WARRENTON PLANNING COMMISSION
Regular Meeting | December 8, 2022 | 6:00pm
Warrenton City Hall Commission Chambers | 225 S Main Avenue, Warrenton, OR 97146

STAFF REPORT

TO: The Warrenton Planning Commission
 FROM: Jay Blake, Planning Director
 DATE: December 8, 2022 – Hearing Continuation
 SUBJ: SUB 22-02: Buoy 10 Land Preliminary Plat
 Nathan Johnson, Sunrise Homes, Inc.
 Tax Parcel: 81009BC01100

TO: The Warrenton Planning Commission
FROM: Jay Blake, Planning Director 
DATE: October 13, 2022
SUBJ: SUB 22-02: Buoy 10 Land Preliminary Plat
Nathan Johnson, Sunrise Homes, Inc.
Tax Parcel: 81009BC01100

PRELIMINARY PLAT (REPLAT)
 BUOY 10 LANDING SUBDIVISION
 354 PACIFIC DRIVE, WARRENTON, OR 97146

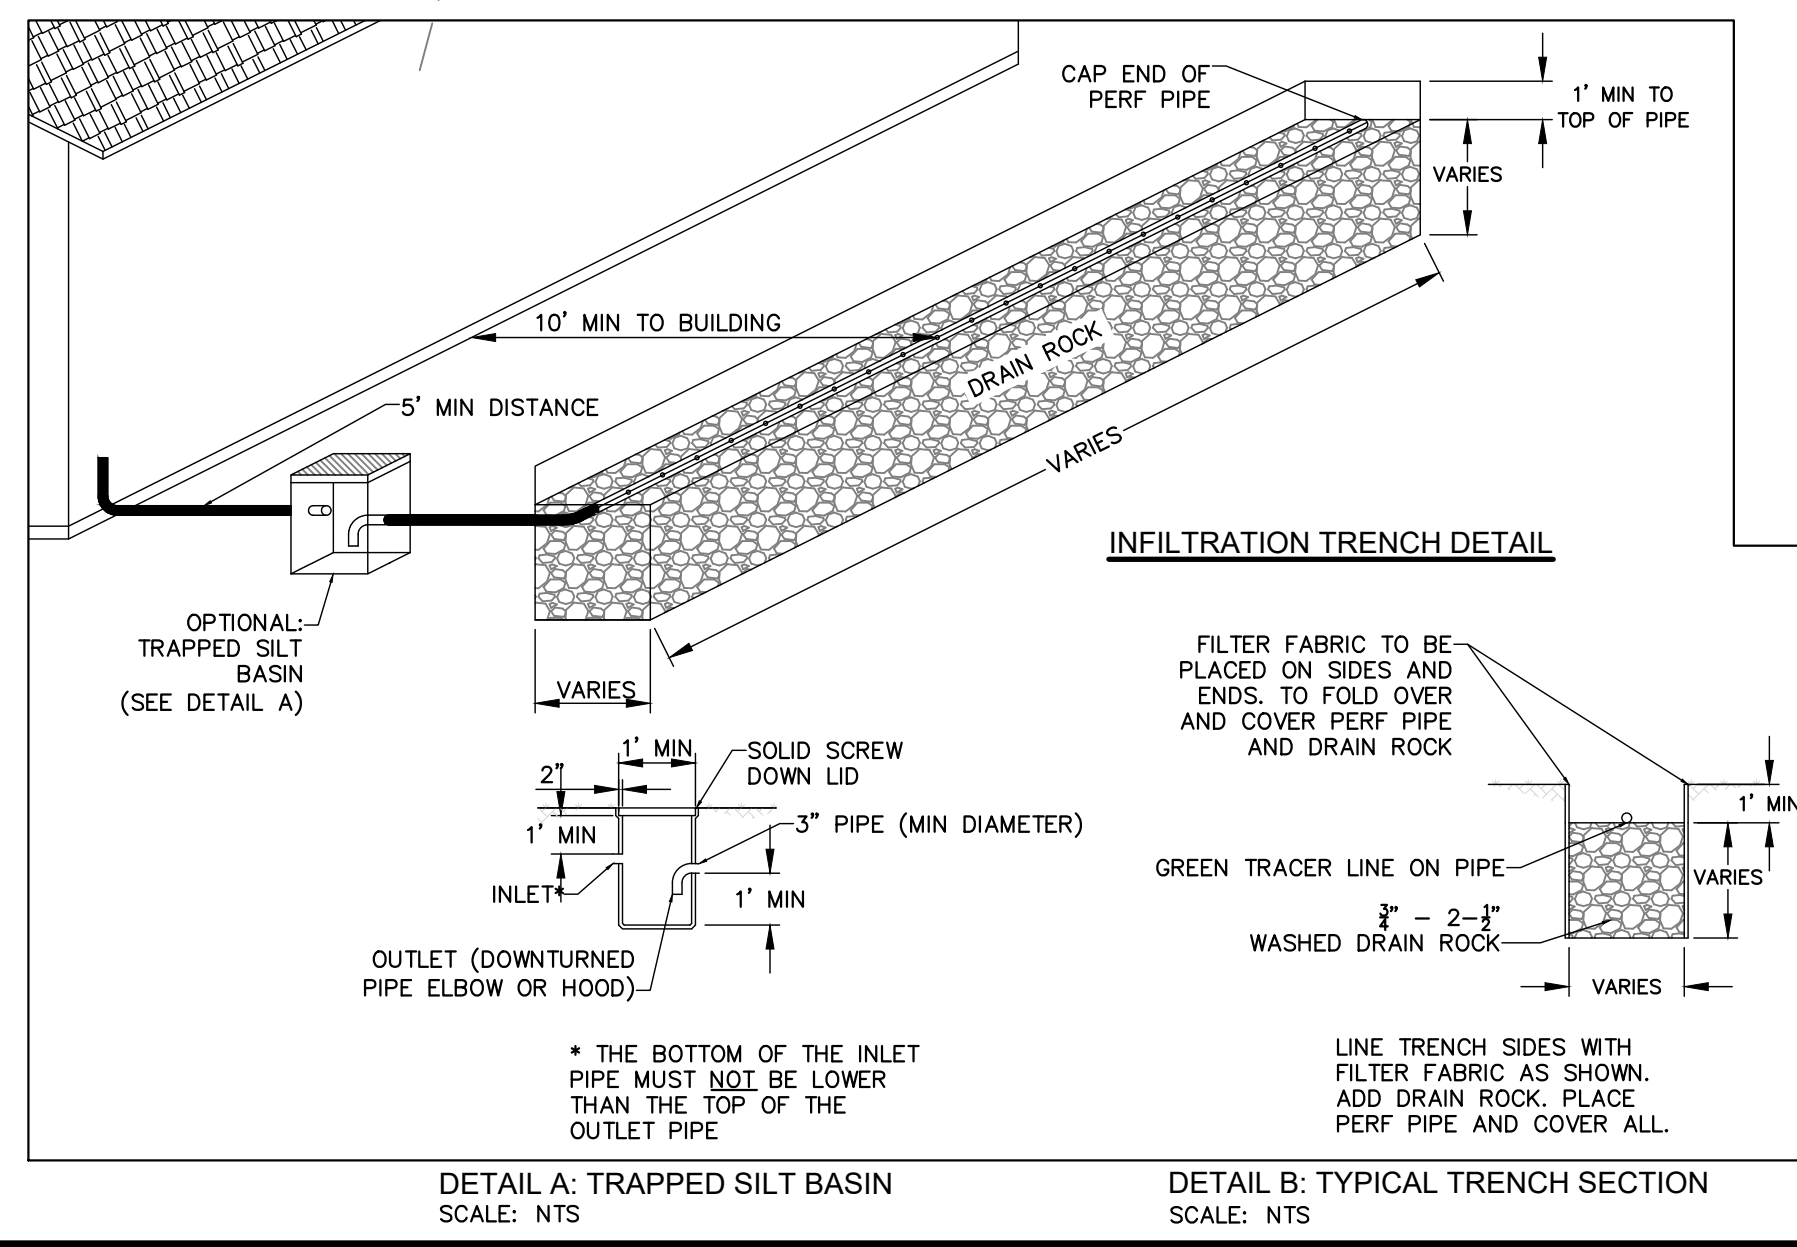
- Sheet 4 includes a table depicting each lot area, building footprint areas for all seven lots, and lot coverage for each lot.
- All lots are below the 40 percent lot coverage standard.
- All buildings will be 28 feet tall.
- The proposed structures meet required front yard, rear yard, and side yard setback requirements. Zero lot lines are allowed internally for attached single family structures.

- The lots range in area from 2,925 to 3,660 square feet; lot widths range from 29.25 to 36.66 feet; lot depths are all 100 feet. All lots meet the minimums for duplex lot standards.
- Sheet 4 includes a table depicting each lot area, building footprint areas for all seven lots, and lot coverage for each lot.
- All lots are below the 40 percent lot coverage standard.
- All buildings will be 28 feet tall.
- The proposed structures meet required front yard, rear yard, and side yard setback requirements. Zero lot lines are allowed internally for attached single family structures.

COMPOSITE SITE & UTILITY PLAN
BUOY 10 LANDING SUBDIVISION
354 PACIFIC DRIVE, WARRENTON, OR 97146

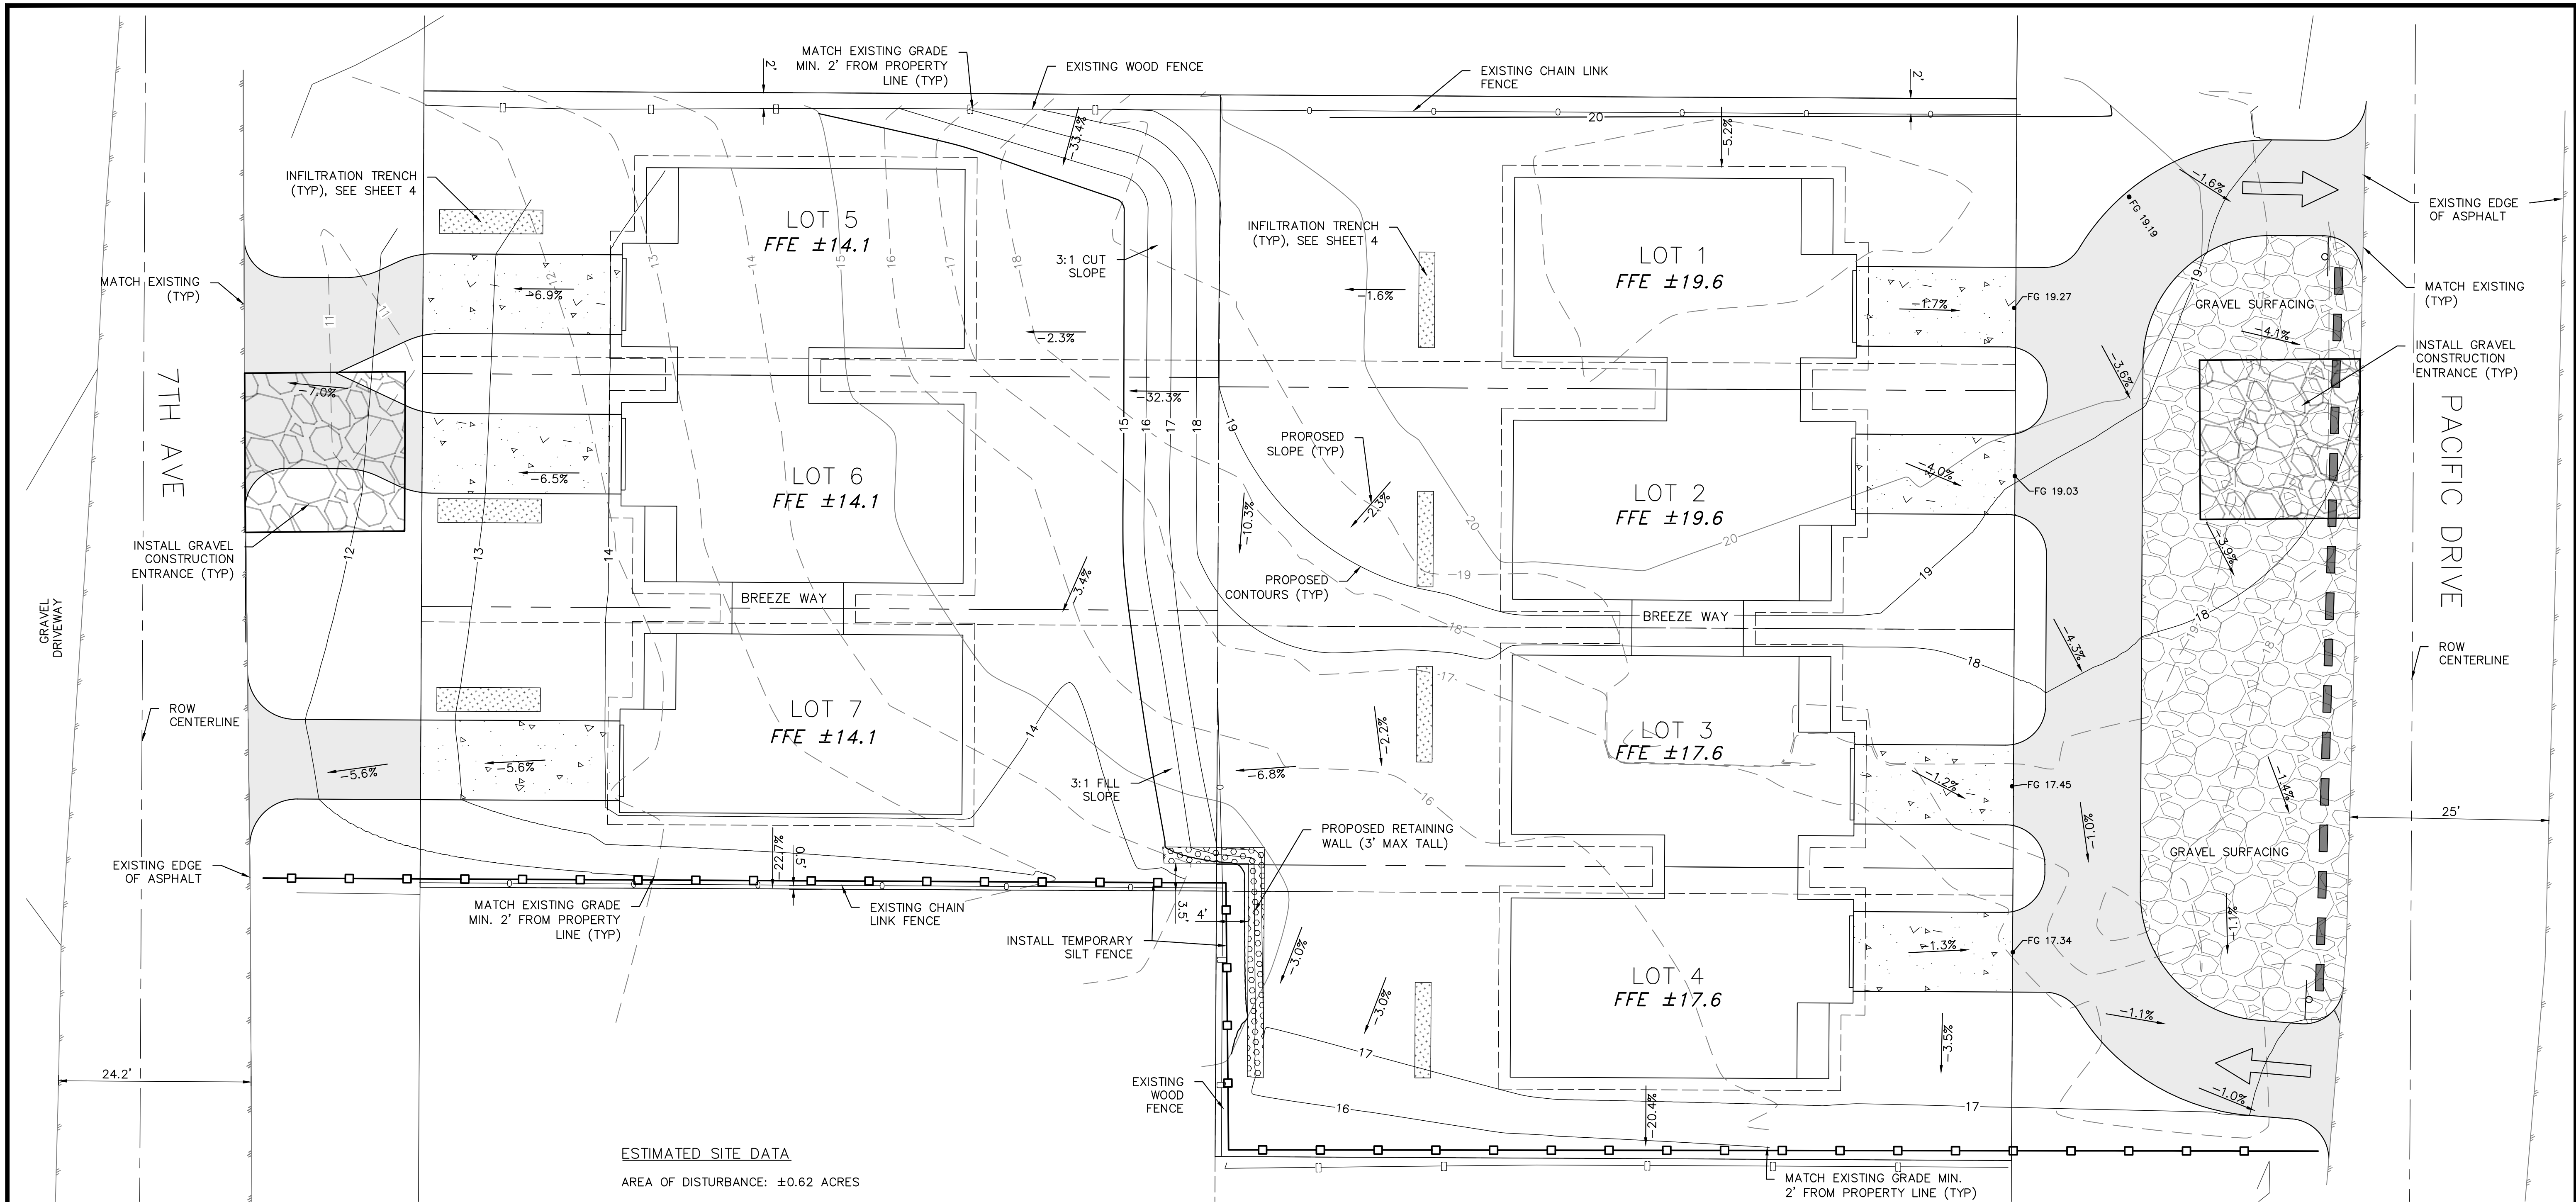
- The site plan should include the location of a fire hydrant located within 250 feet of the buildings as required by the Fire Code. The applicant shall confirm that adequate flows exist to meet fire flow needs.

- The site plan should include the location of a fire hydrant located within 250 feet of the buildings as required by the Fire Code. The applicant shall confirm that adequate flows exist to meet fire flow needs. *(See the additional comments from Fire Chief Brian Alsbury below).*

- *The Warrenton Fire Chief, Brian Alsbury has reviewed the proposal and measured the distances from three nearby fire hydrants. He concluded that no new fire hydrants are needed. He concluded that the location of existing hydrants and the sprinkling of the structures will provide adequate fire protection. A copy of his correspondence is in the file.*

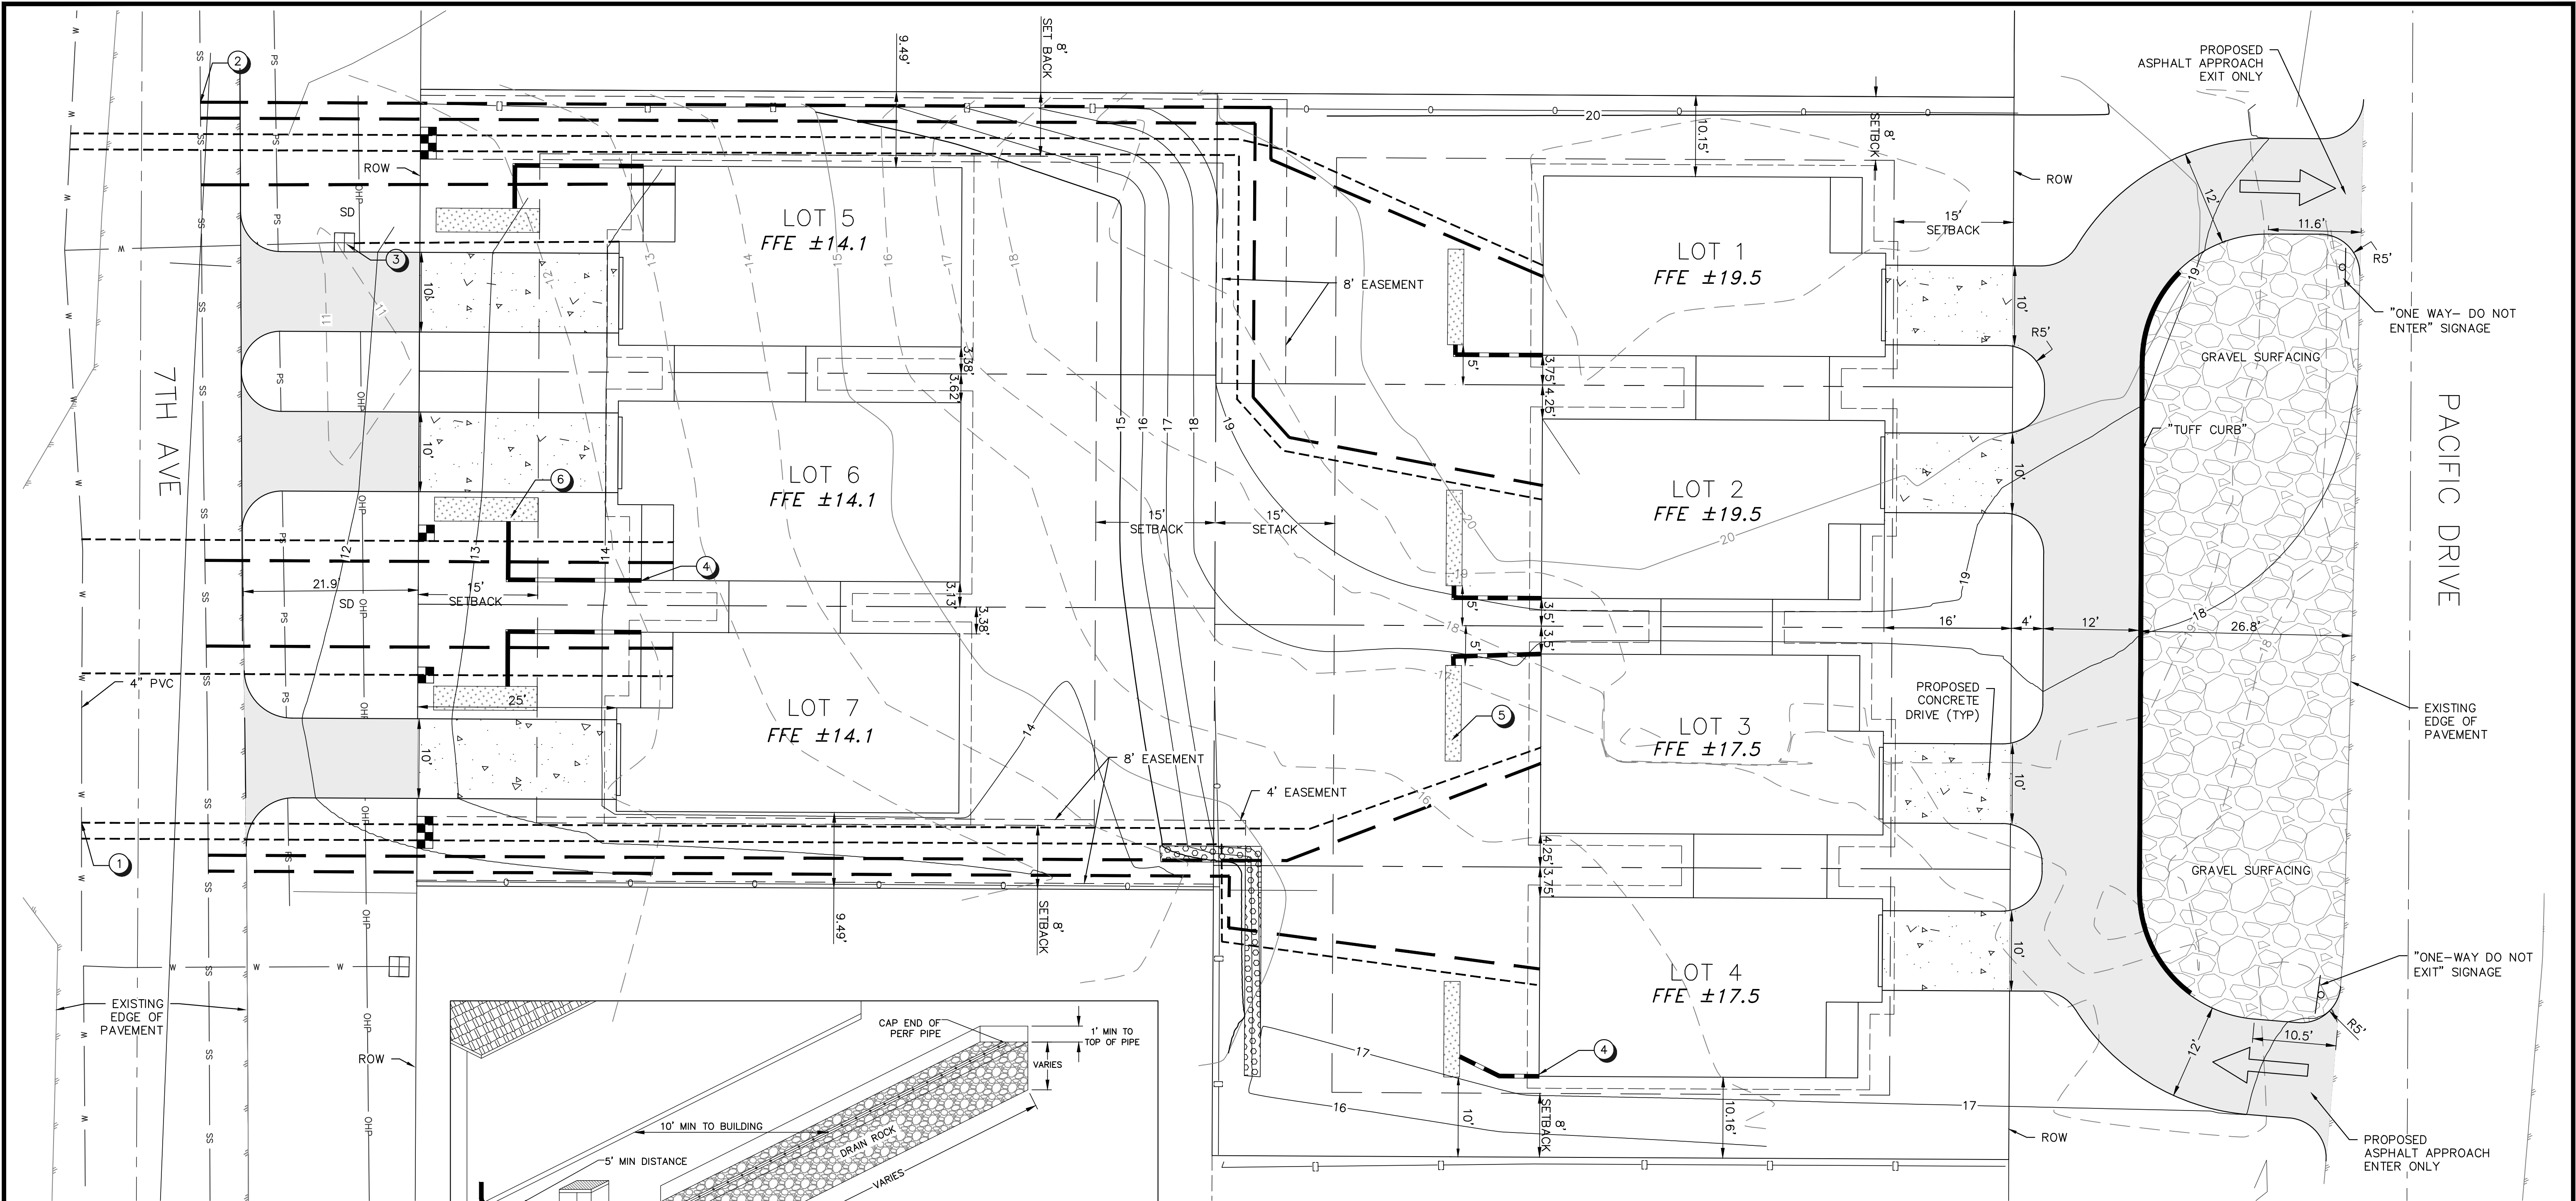
Sheet 5 illustrates the preliminary erosion control plan, which consists primarily of a temporary silt fence along the eastern property line from Hwy 104 to 7th Avenue. Upon completion of grading, the disturbed areas will be stabilized until building construction is completed on each lot and permanent landscaping is installed. A final erosion control plan will be prepared and submitted with the grading permit application after preliminary plat approval. This standard is satisfied.

Sheet 5 illustrates the preliminary erosion control plan, which consists primarily of a temporary silt fence along the eastern property line from Hwy 104 to 7th Avenue. Upon completion of grading, the disturbed areas will be stabilized until building construction is completed on each lot and permanent landscaping is installed. A final erosion control plan will be prepared and submitted with the grading permit application after preliminary plat approval. This standard is satisfied.
